LICENSEE EVENT REPORT

POWER AUTHORITY OF THE STATE OF NEW YORK
JAMES A. FITZPATRICK NUCLEAR POWER PLANT

DOCKET NO. 50-333

ATTACHMENT TO LER 83-008/01T-0

Figure 3.1-2a
 Operating Limit MCPR vs. τ ($\leq 4.1.E$)
 For 8x8 and 8x8R Fuel Type

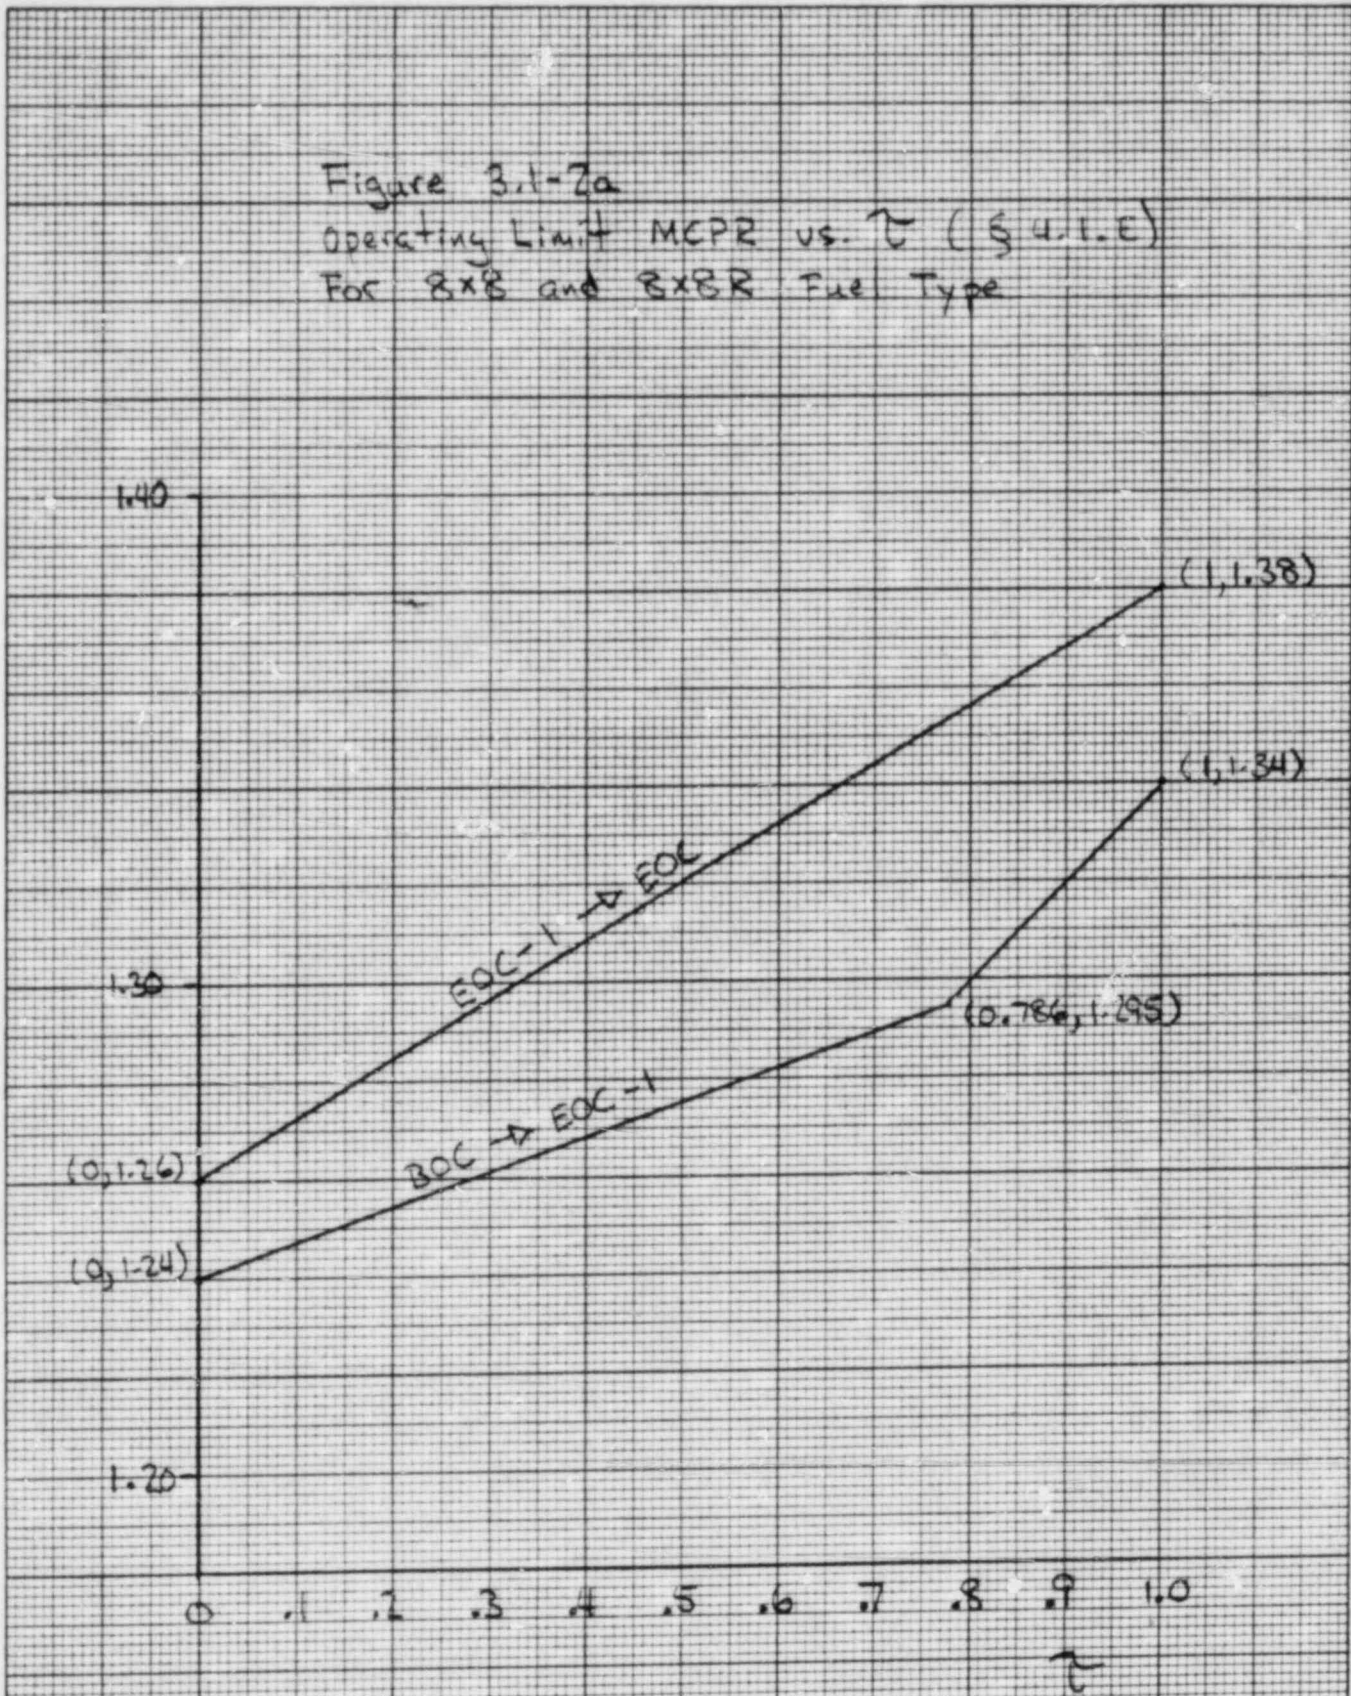
The corrective action for this event is to submit revisions to Technical Specification 3.1.B.1 and Technical Specification figures 3.1-2a, 3.1-2b and 3.2-2c to the NRC. Until such time as the revised Technical Specifications are approved, the plant commits to using the proposed limiting CPR values in calculations to verify compliance to thermal limits.

These values are:

3.1.B.1 MCPR Operating Limit for Incremental Cycle
 Core Average Exposure
